Hi-Fi Products Service Bulletin

Model: D-211

No. 316

Subject: CD Does Not Play (Focus Not Achieved).

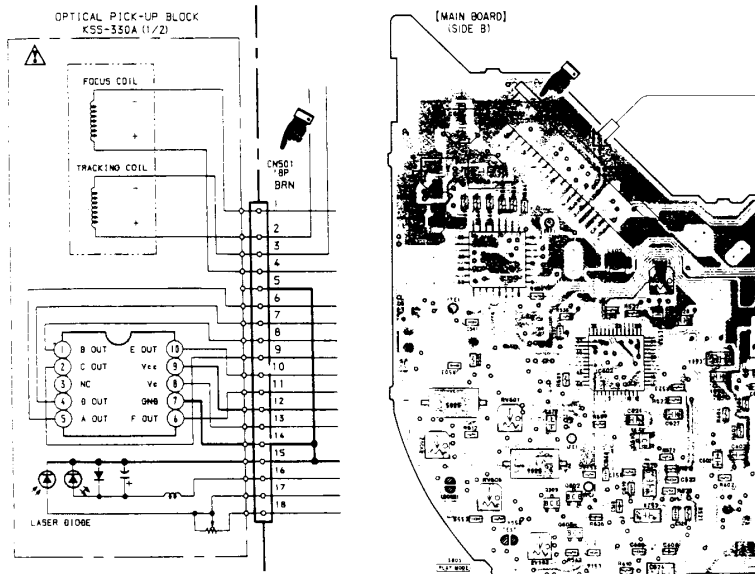
Symptom:
(51) The CD does not play. The unit shuts down because focus is not achieved.

Solution: Replace CN-501.

REF	DESCRIPTION	PART NUMBER
CN-501	CONNECTOR, SOCKET 18P	1-695-154-11
